DATE: May 22, 2018  
TO: Shelby Campbell, SFPUC  
FROM: Tania Sheyner, Planning Department  
RE: Case No. 2018-002921PPA  
1550 Evans Avenue

## Preliminary Project Assessment

*Date:* May 22, 2018  
*Case No.:* **2018-002921PPA**  
*Project Address:* 1550 Evans Avenue  
*Block/Lot:* 5203/035  
*Zoning:* Core Production, Distribution, and Repair (PDR-2) District  
65-J Height and Bulk District  
India Basin Industrial Park Special Use District  
*Project Sponsor:* San Francisco Public Utilities Commission  
Shelby Campbell – 415-554-3431  
*Staff Contact:* Julie Moore – 415-575-8733  
[Julie.Moore@sfgov.org](mailto:Julie.Moore@sfgov.org)

**RE:** SDAT Review  
Case NO. 2018-002921PPA  
Address: 1550 Evans Avenue  
Neighborhood: Bayview  
Zoning: PDR-2  
Area Plan: Bayview Hunters Point

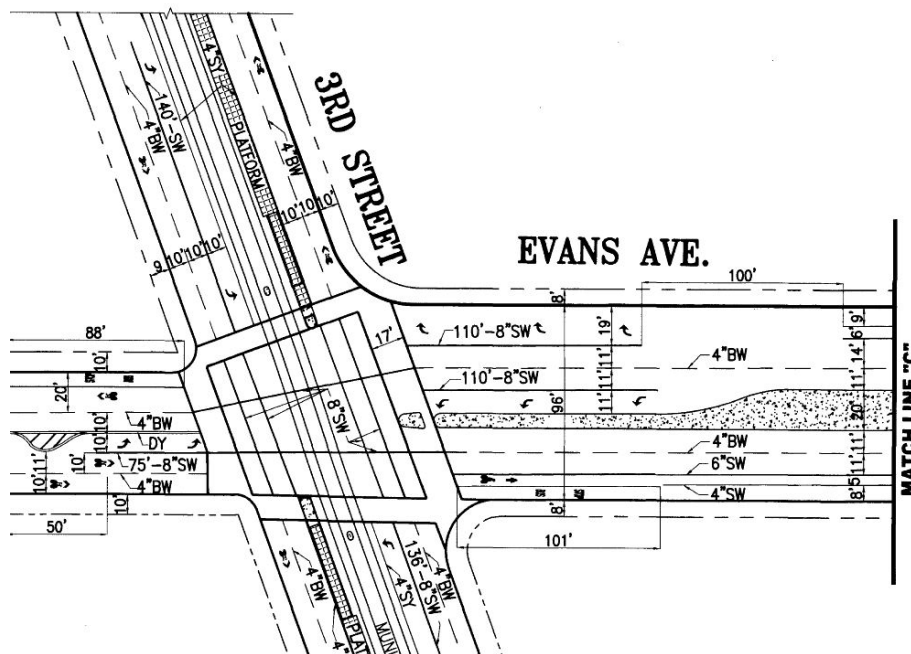
- SF Public Works plans to modify striping to add a right-turn pocket and to tighten its curb radii along the Evans Avenue frontage.

- The project sponsor will be expected to propose a lighting plan and provide photometric studies for Evans Avenue and Newhall Street.
- See Item #11 under the "Interagency Coordination and Additional Guidance" section below

- SDAT recommends providing a passenger loading zone (white zone) in front of the new education center along Newhall Street.
- Please provide more information on the number of children proposed to use the child care use and the number and size of events proposed at the site.
- Please refer to Item #2 under "Interagency Coordination and Additional Guidance" section below.

- Please indicate the location of the transformer vault on the plan set.
- SDAT does not support locating electrical transformers within the public ROW at this location.
